**HORIZON®. HRZ-D MANUAL**  
**ADDENDUM**  
June 1980

ADDENDUM to: HRZ-D MANUAL, REVISION\_1

JUNE 4, 1980

HORIZON MOTHERBOARD HRZ-MB-4		SHT
BUFFERS, STATUS, PARALLEL PORTS		4 of 5
© 1977, NORTH STAR COMPUTERS, INC.

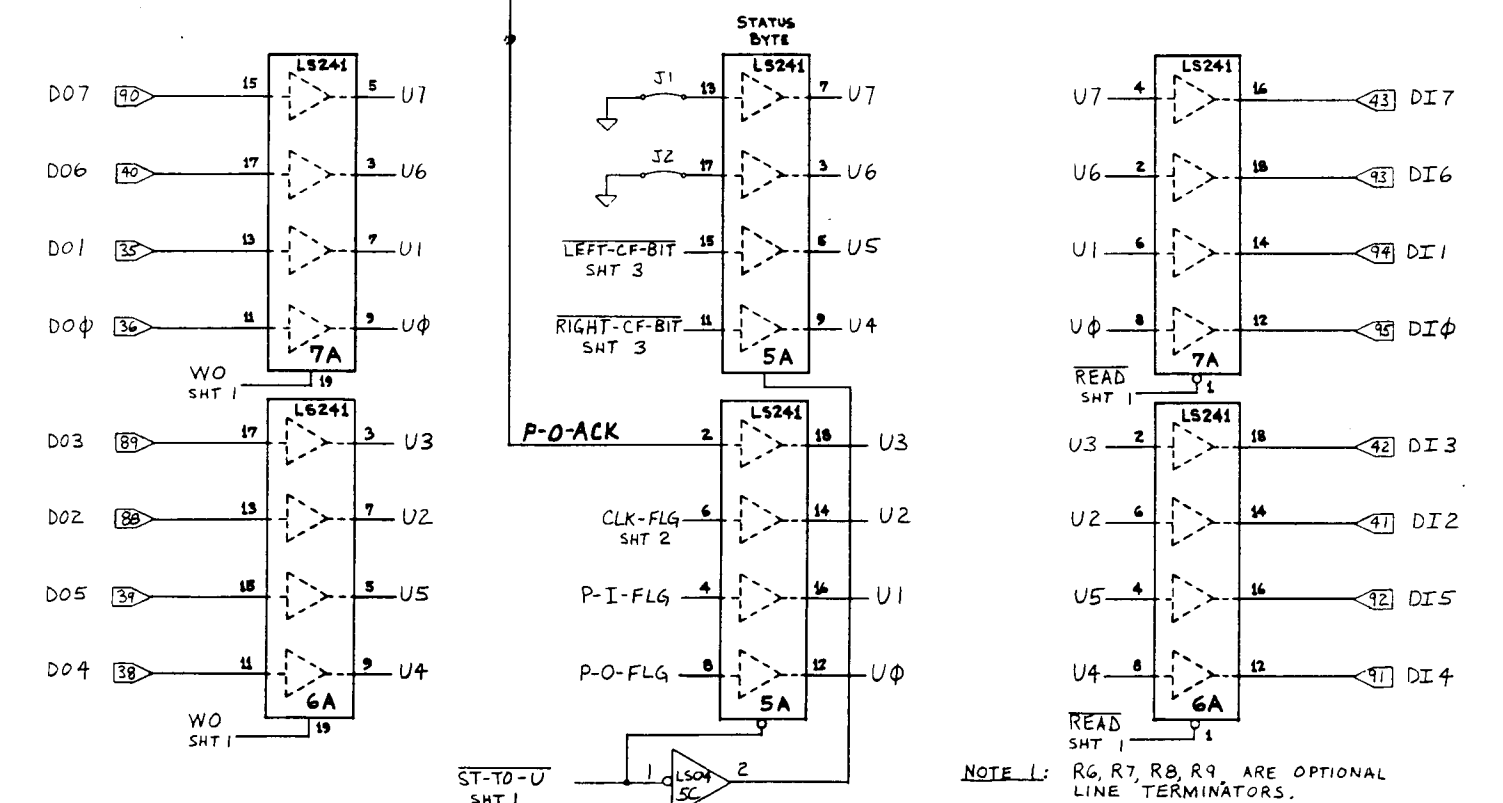
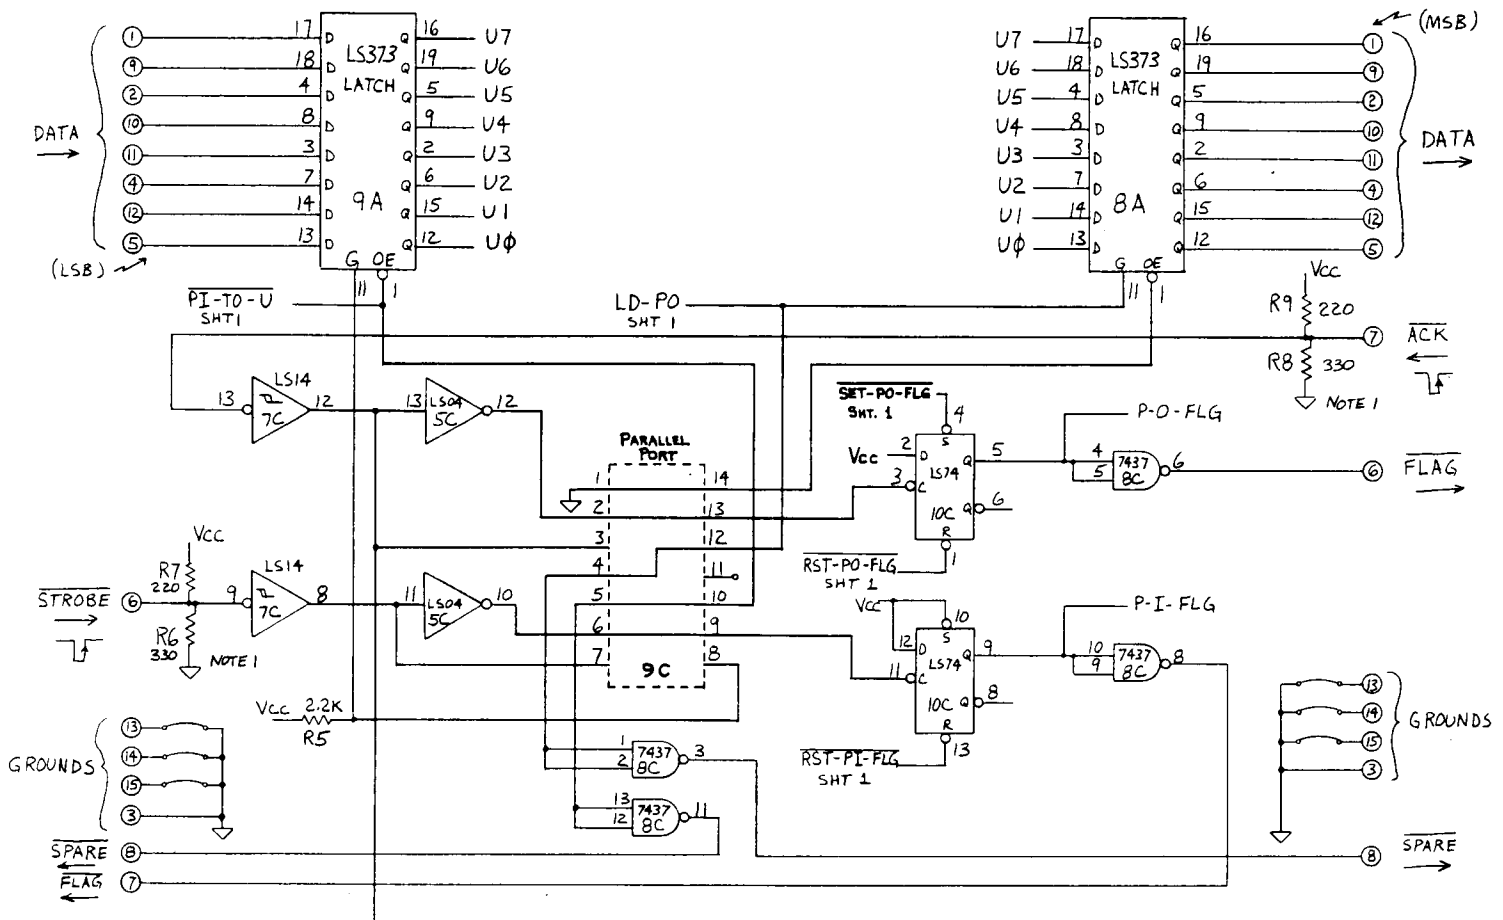
11) For all HORIZON Computer Systems containing motherboards marked "HRZ-MB-4", the following five pages of schematic drawings supersede pages 88, 89, 91, and 92 of the HORIZON Manual.

NOTE 1: R6, R7, R8, R9, ARE OPTIONAL LINE TERMINATORS.

HORIZON CHASSIS/MOTHERBOARD MB-4	SHT
POWER SUPPLIES	5 of 5
© 1977, NORTH STAR COMPUTERS, INC.

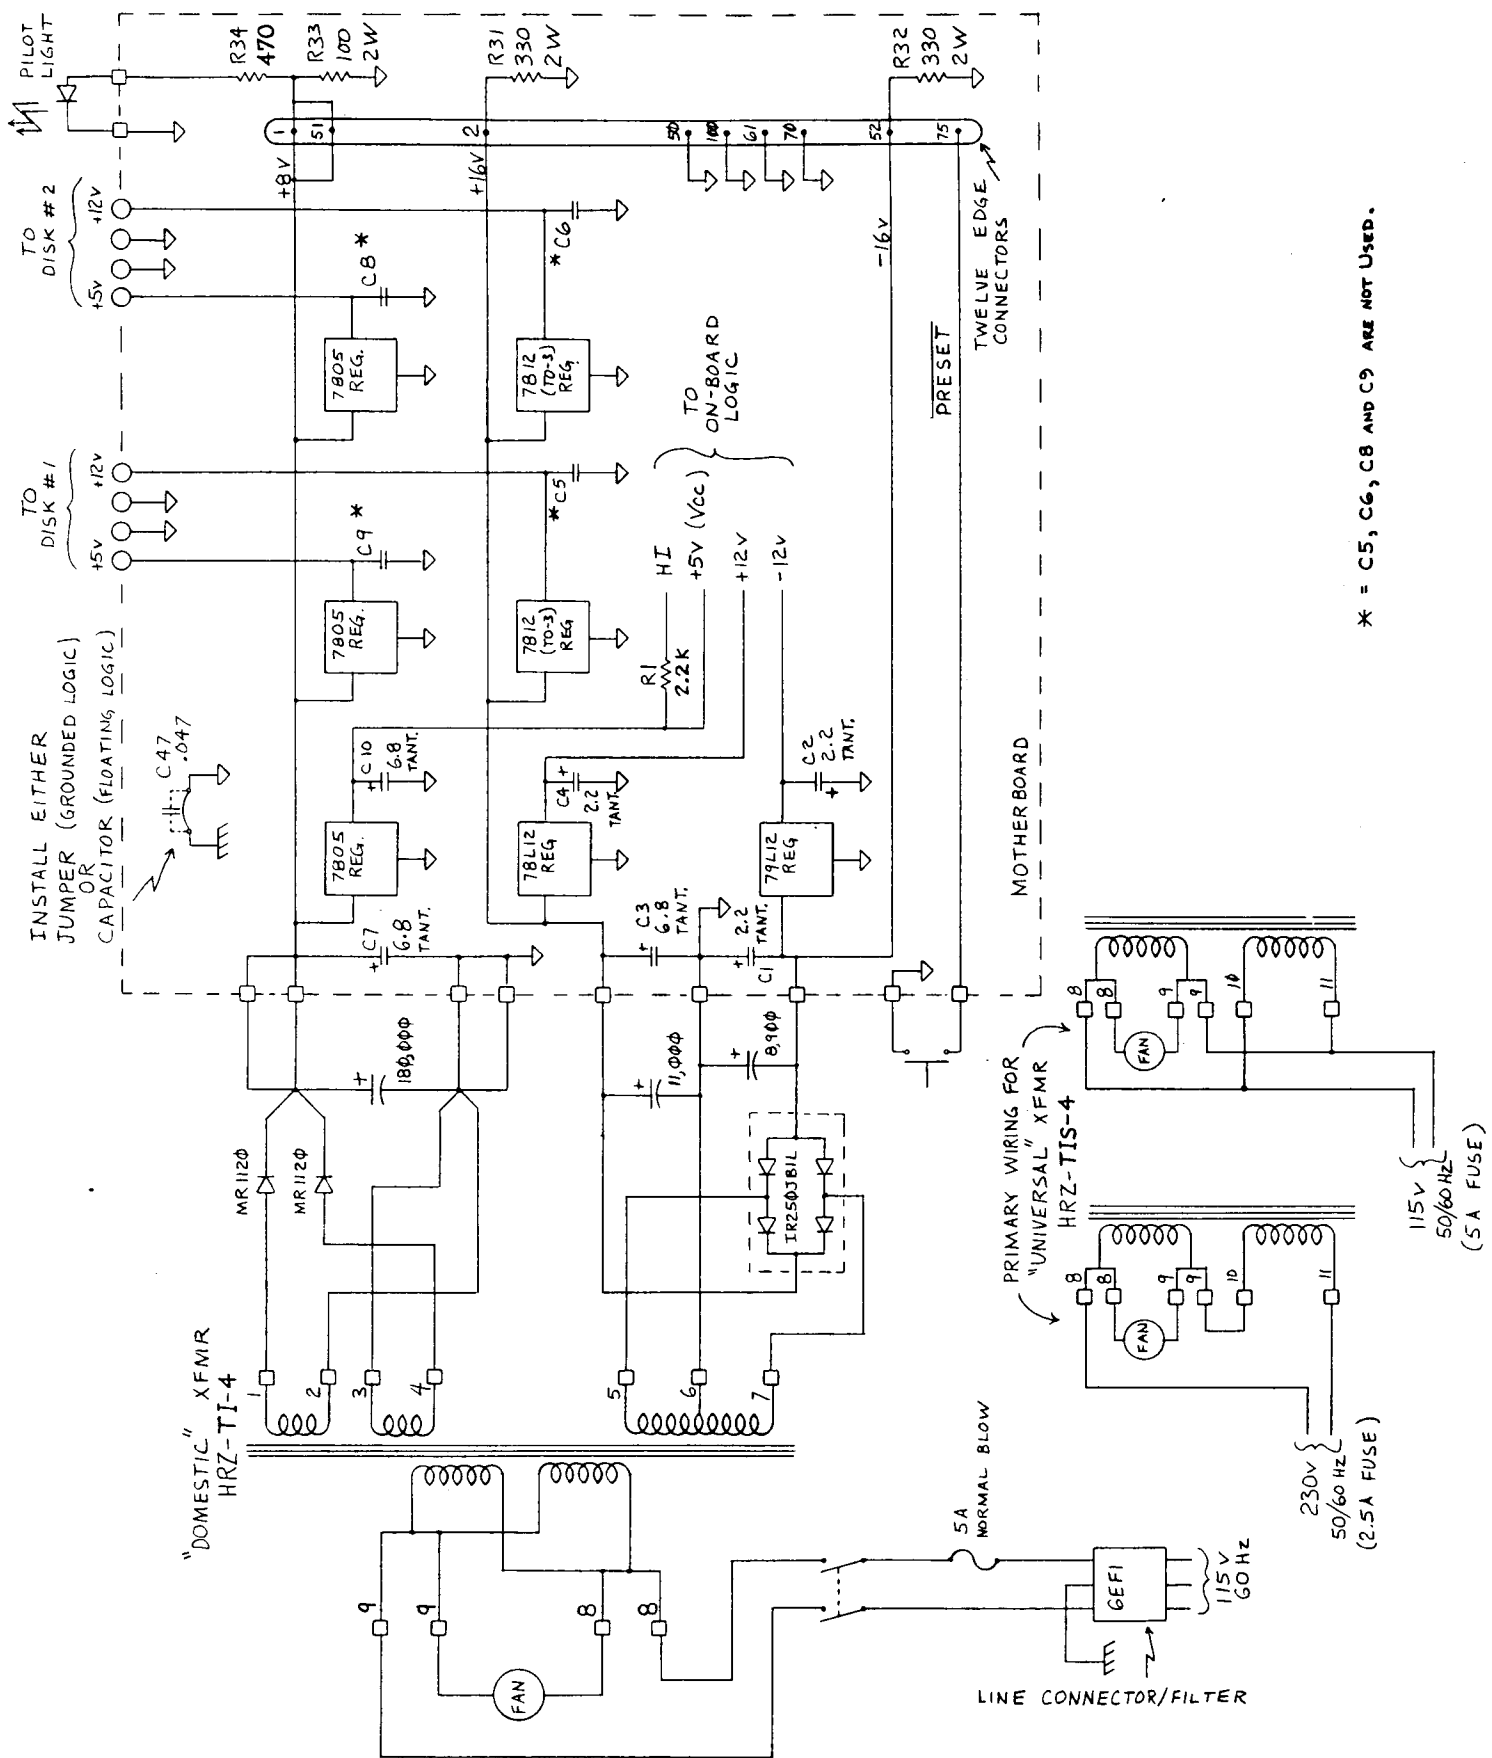
\* = C5, C6, C8 AND C9 ARE NOT USED.
